Federal Land Use, Design, and Transaction Approval Submission

NATIONAL CAPITAL COMMISSION Commission de la capitale nationale	No.	2019-P183
	То	Board of Directors
DECISION	Date	2019-01-24/25

Champlain Node Parking Lot Relocation and Landscape Design

2018-P183 - Champlain Node Site Plan and Parking Lot Relocation Design (C)

- Appendix A Site Plan
- Appendix B Detailed Design Plan

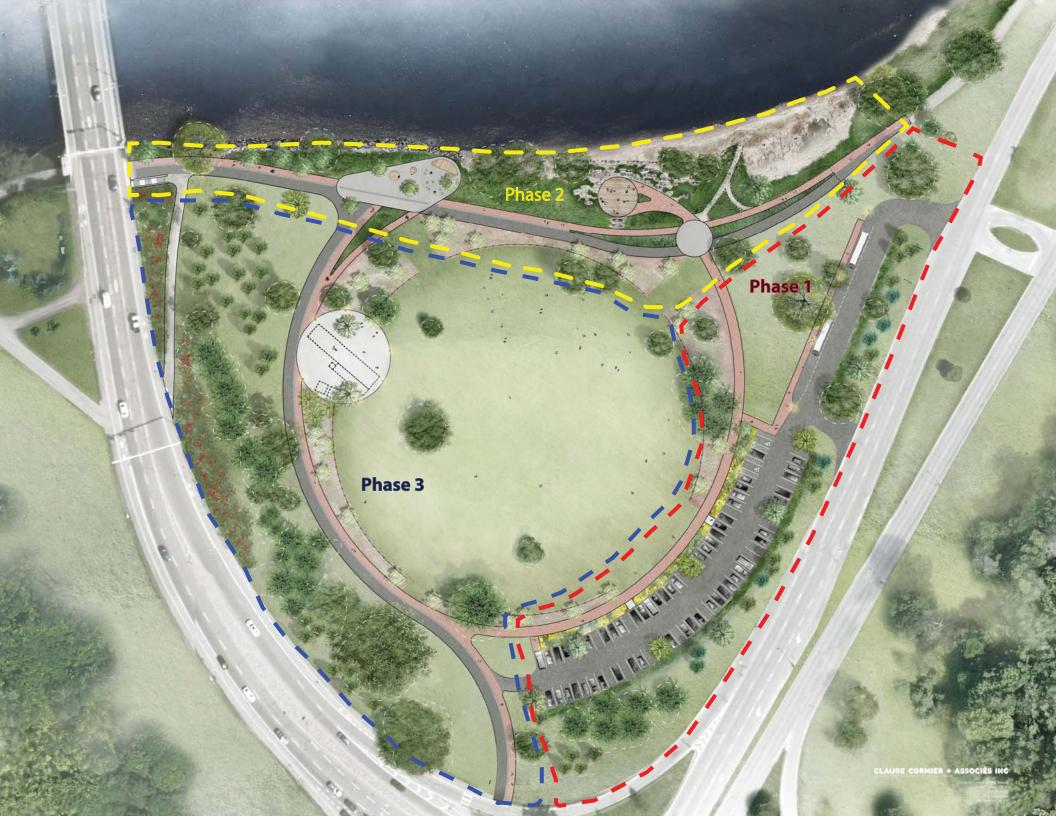
- The node should be planned considering the Ottawa River South Shore Riverfront Park Plan.
- Members commended the relocation of the parking from the edge of the river, and the use of bioswales.
- The shape and overall design is simple and elegant.
- A winter strategy should be examined, including all-season facilities in the service node.
- The service node facilities should be designed to be flood resilient.
- The seasonal flooding that will occur in the central grassed area could be celebrated by articulating the frequently flooded area in the design.
- Public art or minor commemoration should
 ACPDR / CCUDI

be integrated in the site.

- Picnic amenities and shelter should be considered, as well as food services.
- Consultation with First Nations for narratives is encouraged.

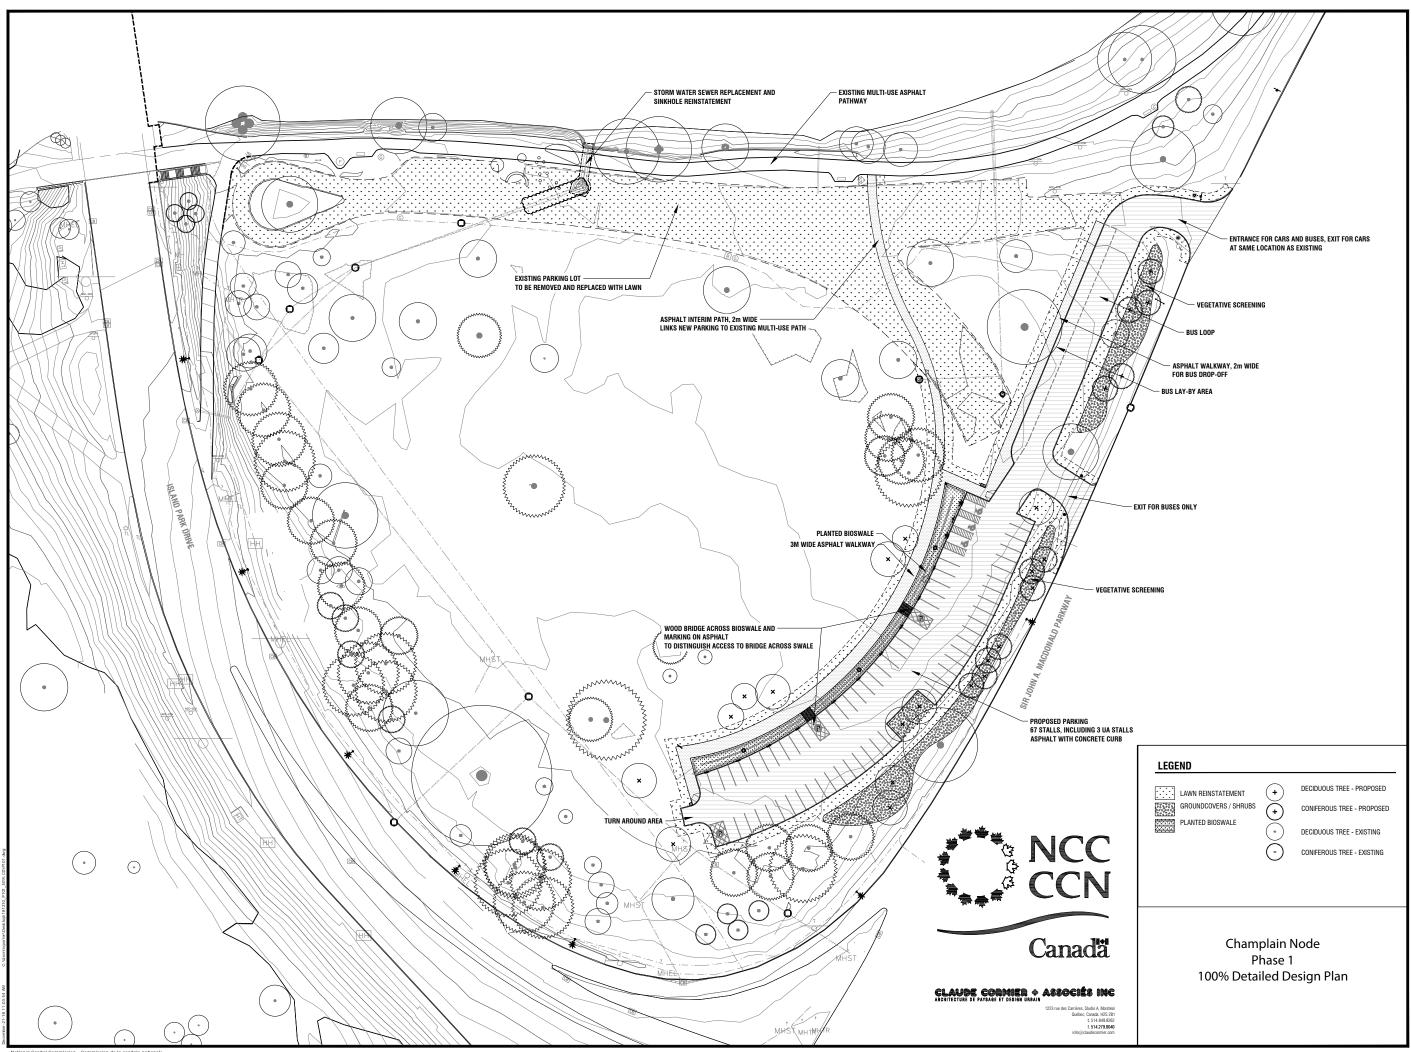
- The parking should not be a commuter parking lot. Charging a fee for weekday, daytime use will discourage commuters from using it and reduce the need for additional spots.
- The parking should be both aesthetic and safe. The design should be adjusted to ensure that people and cars can manoeuver safely.
- There should be a way for cars to leave without backing up if there is no spot available. Solar-powered parking management signage could help resolve circulation issues.
- The parking lot should be structured to appear less prominent. One member suggested using grass pavers.
- Alternatives to colored asphalt should be considered due to high cost and repair

challenges associated with colour matching.
